**NEW MEXICO ENVIRONMENT DEPARTMENT  
INSPECTION OF PUBLIC RECORD REQUEST FORM**

1. NMED's technical completeness determination or additional request for information on New Mexico Copper Corporation's discharge permit application, date range June 28, 2017 through July 19, 2017;
2. NMED determination regarding Copper Flat Copper Mine pit lake being a private water, date range June 28, 2017 through June 19, 2017;
3. Bureau of Land Management request to the Surface Water Quality Bureau to write a letter of concurrence for the Surface Water Quality Bureau's benefit regarding the proposed Copper Flat Copper Mine pit lake and associated patented claims surveys completed and a

To: Shelly Lemon, Chief, Surface Water Quality Bureau  
Michelle Hunter, Chief, Ground Water Quality Bureau  
From:  Melissa Y. Mascareñas, Department Public Records Custodian  
Date: September 6, 2017  
Subject: Request to Inspect Public Records

**Figure 3. NMCC Future Open Pit with Property Boundary**

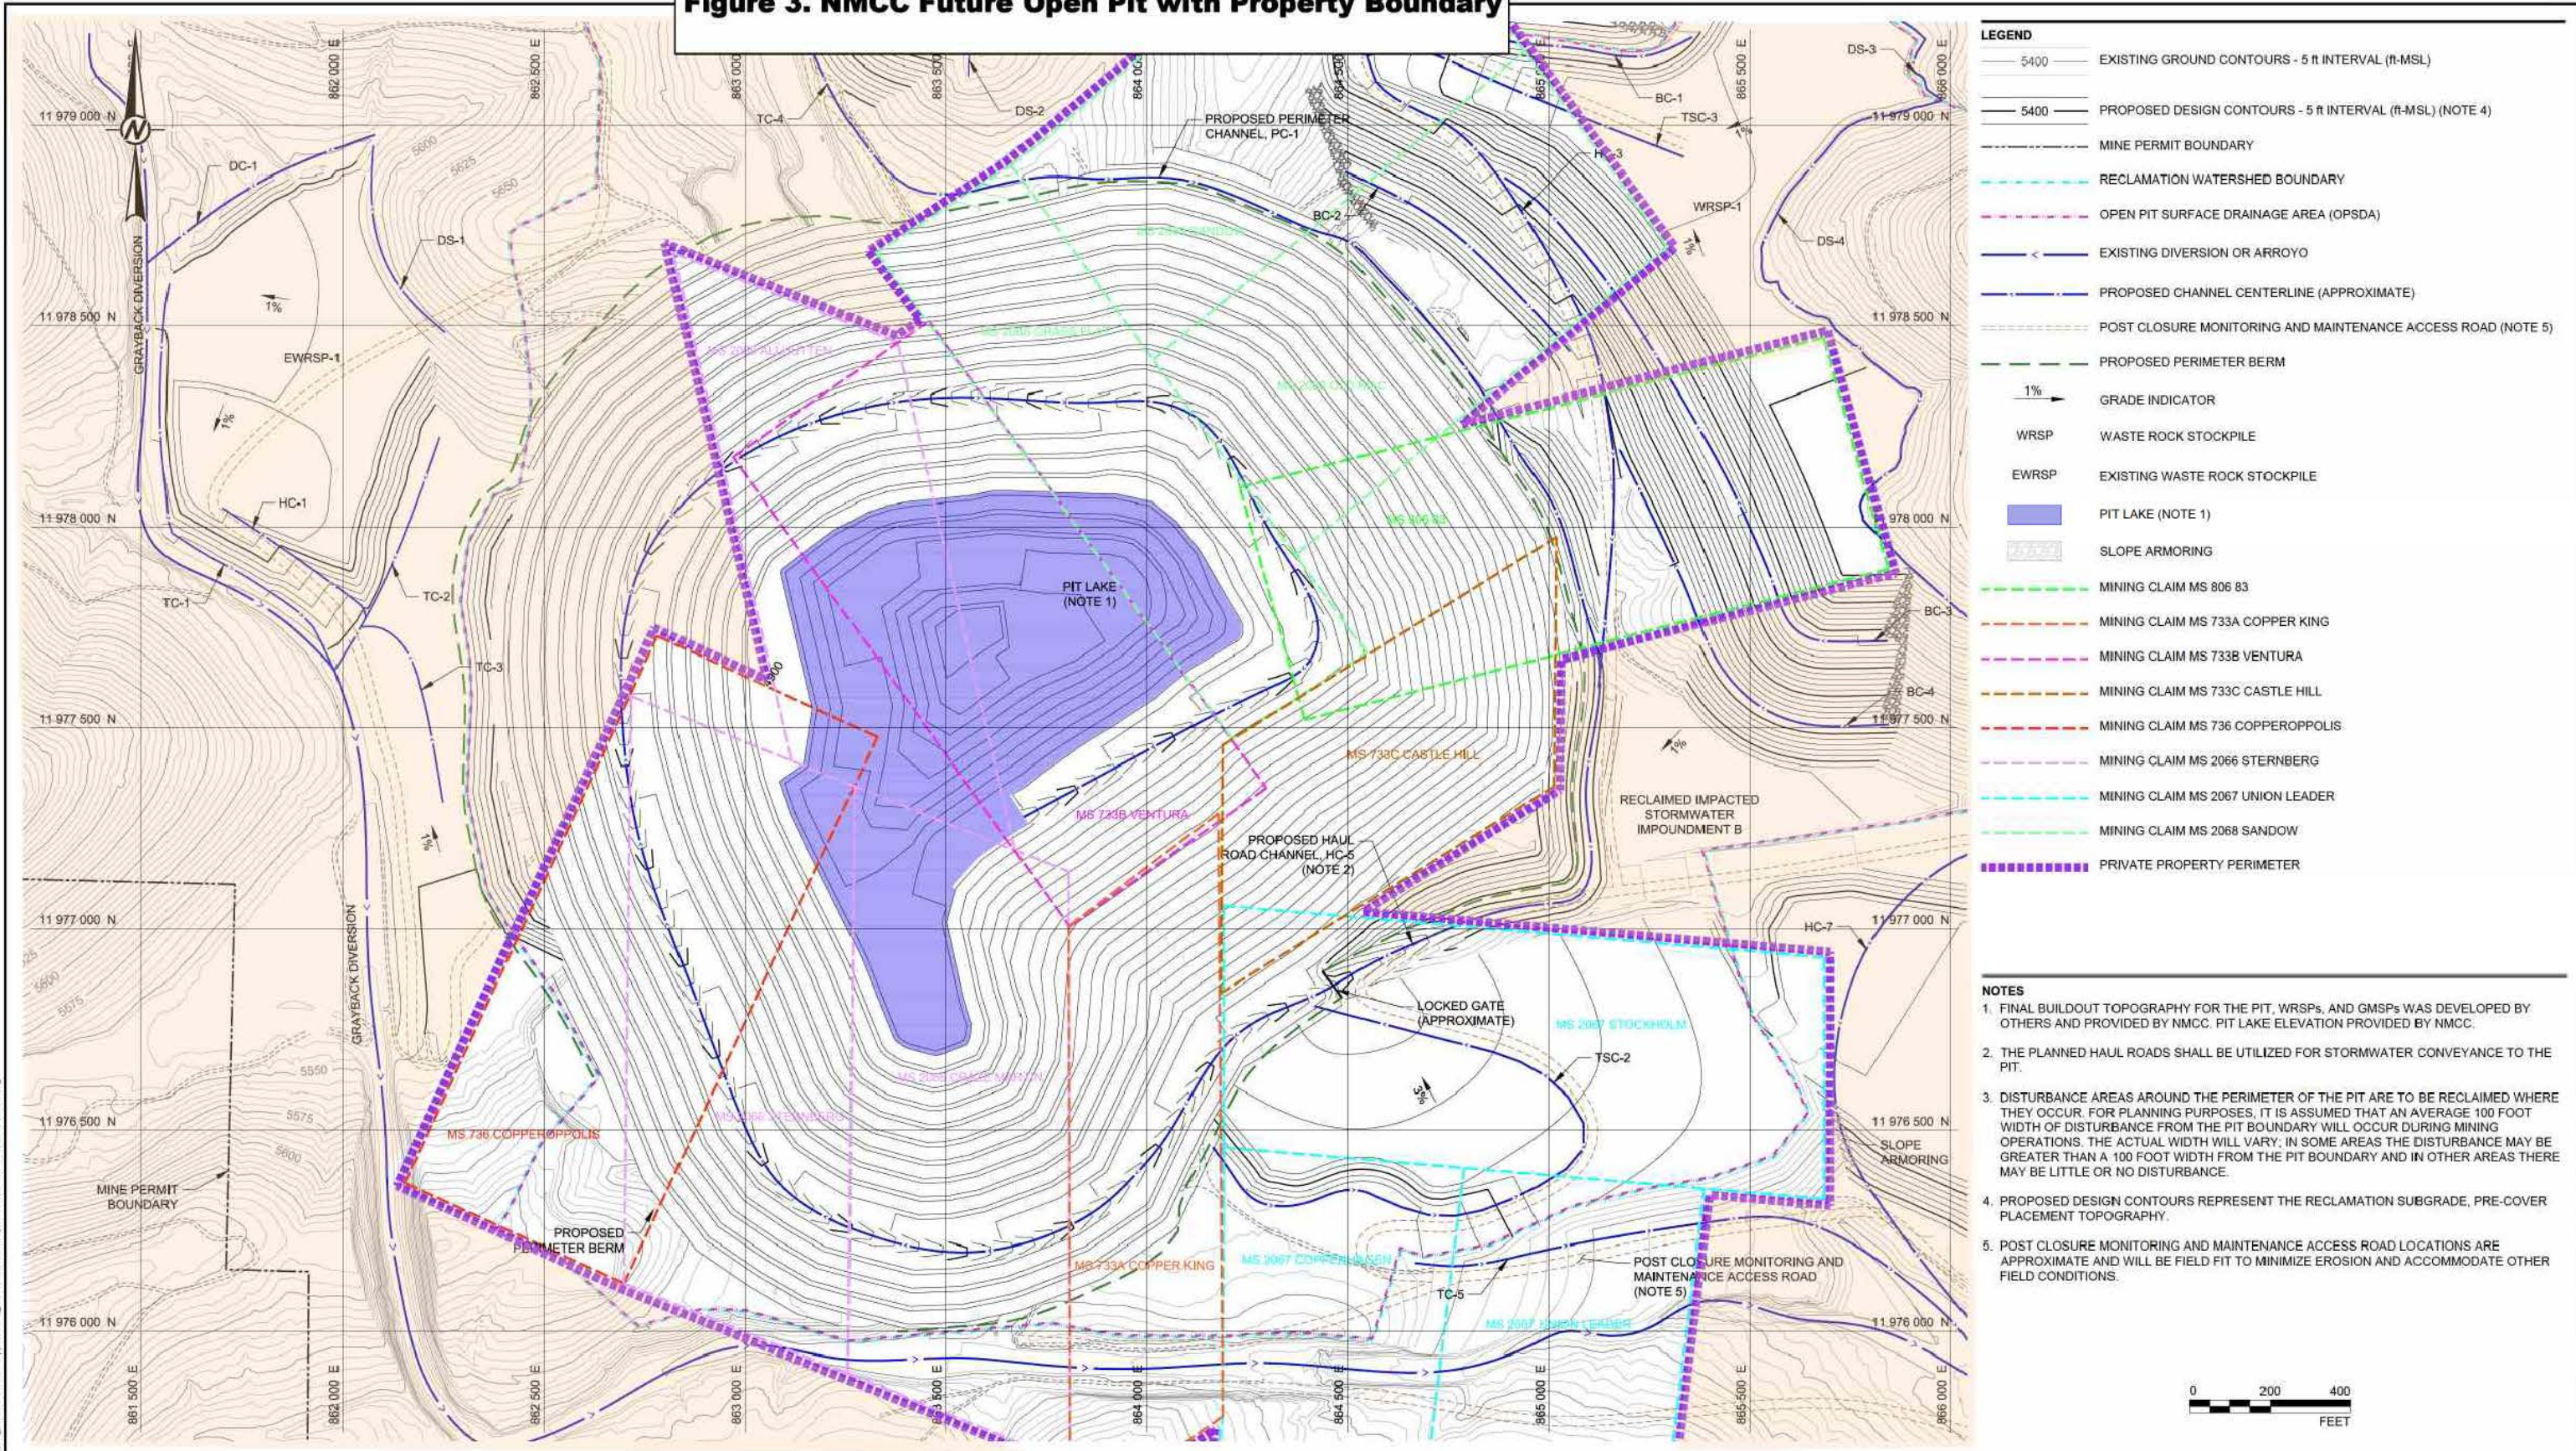
Figure 3 shows the future pit design described in our Mine Reclamation and Closure Plan with NMCC property lines. This figure clearly shows the proposed future pit lake is fully contained within the boundaries of private land owned by NMCC.
